ALTERNATIVE METHODS OR CONSTRUCTION MATERIALS REQUEST

SITE ADDRESS: 4202 5th St SE & 405 39th Ave SE PARCEL NO: 0419106030/0419106028 ZONING: UCX
PROJECT NAME: Dos Lagos
LAND USE APPLICATION #: P-21-0099 & P-21-0100 BUILDING PERMIT APPLICATION #: N/A

RE: Dos Lagos Project
Parcel Nos. 0419106030 and 0419106028
Site Addresses: 4202 5th St SE and 405 39th Ave SE
LS&E Job No. 12896

**STREET TREE PLANTER
 BLOCKOUTS FOR SIDEWALKS**

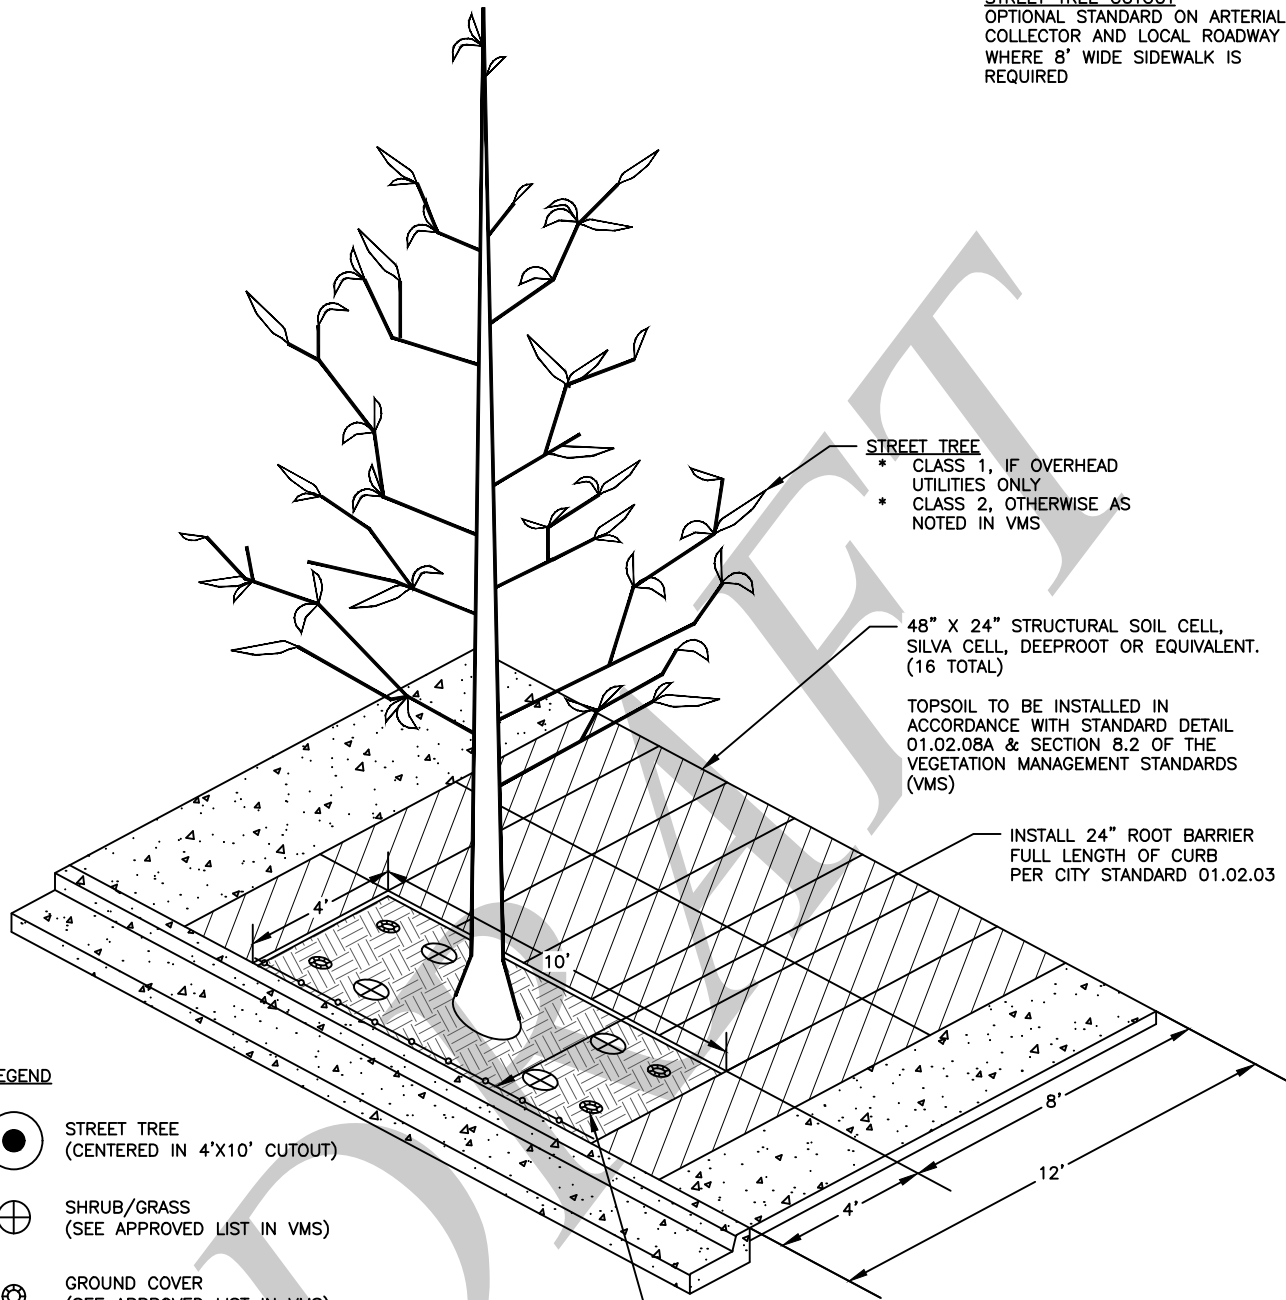
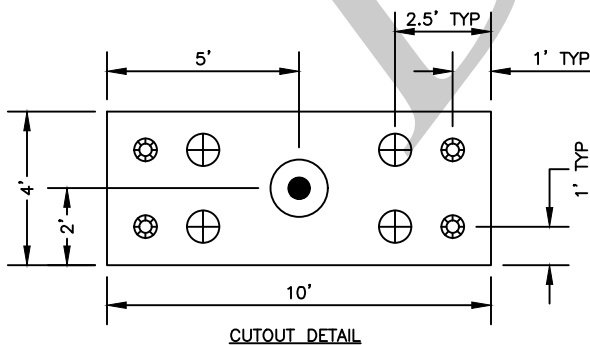
2x4 cutout is not acceptable

I'm following up on the below email for the proposed frontage of this development. I've attached a draft of an updated detail for Street Tree with Planter Block out which shows 8ft wide rather than 6ft sidewalk behind the block outs for a total of 12ft width. This still reduces the width of frontage by 6 ft from the (10ft planter strip + 8ft sidewalk) outlined in the city standards for arterials located in pedestrian oriented zones. The 12ft total width also accommodates the Silva cells dimensions of 2ftX4ft allowing the entire width of the sidewalk for tree growth.

Yes, it led to a discussion of a modified standard of 10 foot wide sidewalks next to curb with 4' X 10' cut outs for street trees. This was what was required for Affinity development on east side of 5th. These would use silva cells for tree root protection. Still more discussion needed on configuration of

silva cells. See the attached detail but using 10-ft instead of 8-ft for the sidewalk width.

UVCHH' TGEQO O GPF CVKQP U'	CRRTQXGF''	F GP KGF''	F CVG''
Development Engineering			11/17/2022
Conditions:			
Per HHunger email dated 12/15/20, attached, and subsequent internal City meetings, the City is willing to accept 4x10 planter blockouts, 12-ft sidewalk, and full-width Silva Cells per the attached Preliminary City Std Detail 01.02.04 (see last page of AMR).			
Planning Department			11/17/22
Conditions: Planning will support reducing the 18 feet of frontage zone improvements (standard 10 foot planter strip and 8 sidewalk) down to 12 feet of frontage sidewalk, with 4 foot X 10 foot street tree cutouts within the sidewalk area. That will provide the benefit of 8 foot walk at each street tree cut out and a wider planter cut out. Silva cells (or equiv.) to provide root pathways to soil areas back of walk need to be provided for the entire width of the 4 foot cutouts and the entire depth of the sidewalk behind each street tree.
